Reference ILdd equations for HCB and MCB

Comments #357 and #358

Adee Ran, Cisco

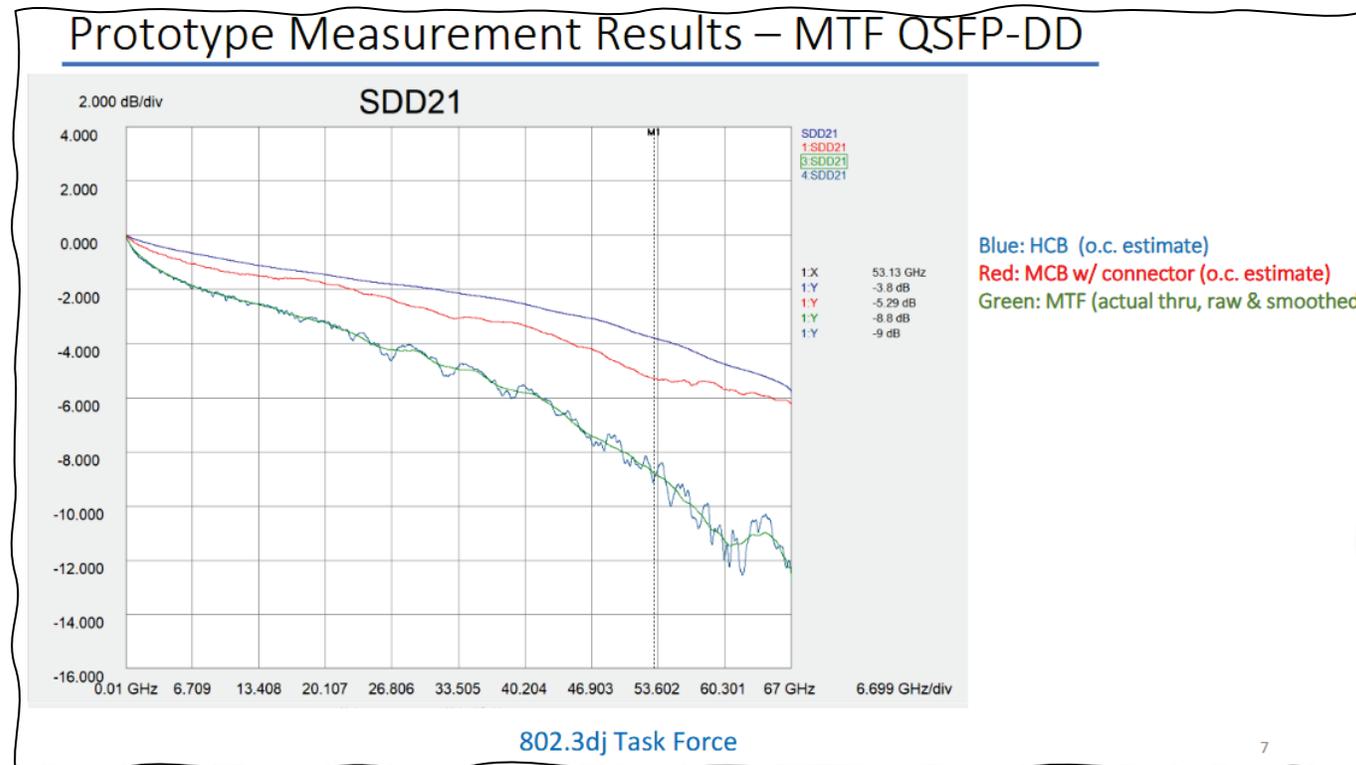
Editor's note: Figure 179B-1 equations have not been adopted, and serve as placeholders.

Editor's note: A TP2 or TP3 test fixtures insertion loss of 3.8 dB @ 53.125 GHz has been adopted. Contributions for Equation (179B-1) to populate Figure 179B-1 are encouraged.

Editor's note: A Cable assembly test fixtures insertion loss of 2.7 dB @ 53.125 GHz has been adopted. Contributions for Equation (179B-2) are encouraged.

- Replace Equations 179B–1 and 179B–2, with the equations shown on slides 4 and 5, respectively.
- Generate Figure 179B–1 accordingly.

HCB fitted ILdd (polynomial in \sqrt{f})

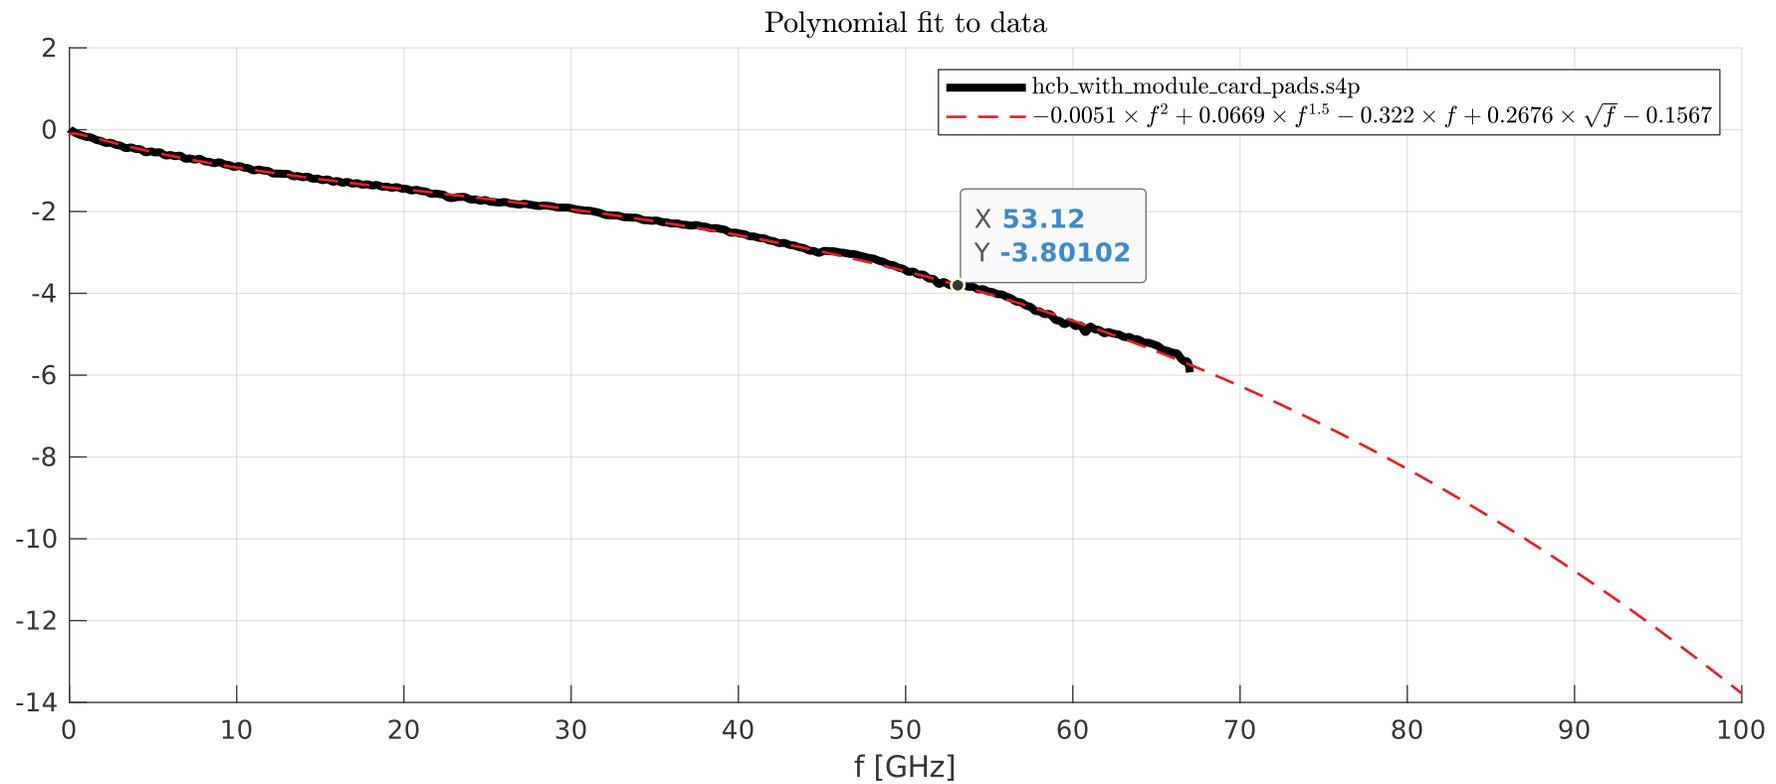
- Using contributed S-parameters from [sekel 3dj 02 2407](#)
 - QSFP-DD test fixture, per slide 7 of [sekel 3dj 01 2407](#)

Reference ILdd values at 53.125 GHz

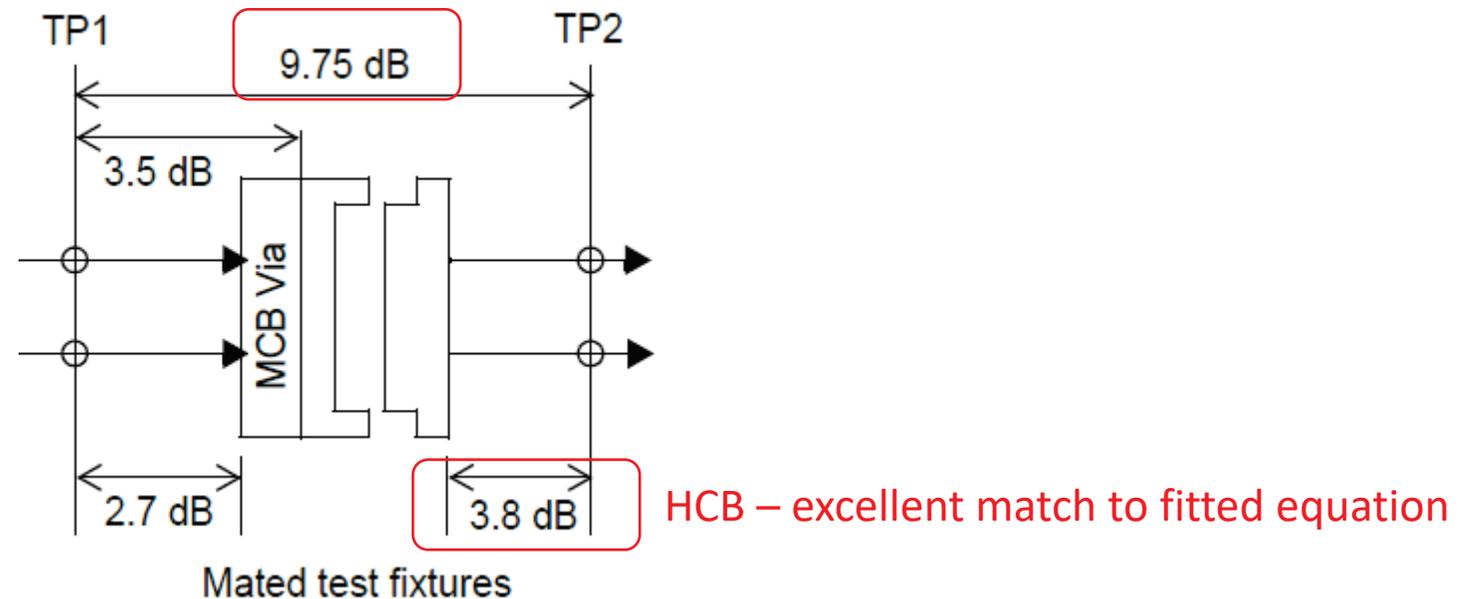
MCB with connector: $9.75 - 3.8 = 5.95$ dB ? (not a good match – equation yields 4.76 dB)

Note that the measured MTF shown on slide 7 of [sekel 3dj 01 2407](#) has ILdd of just 8.8 dB. This would make the MCB + connector become just 5 dB, to which the equation matches better.

However, no S-parameter that yield 9.75 dB were provided.
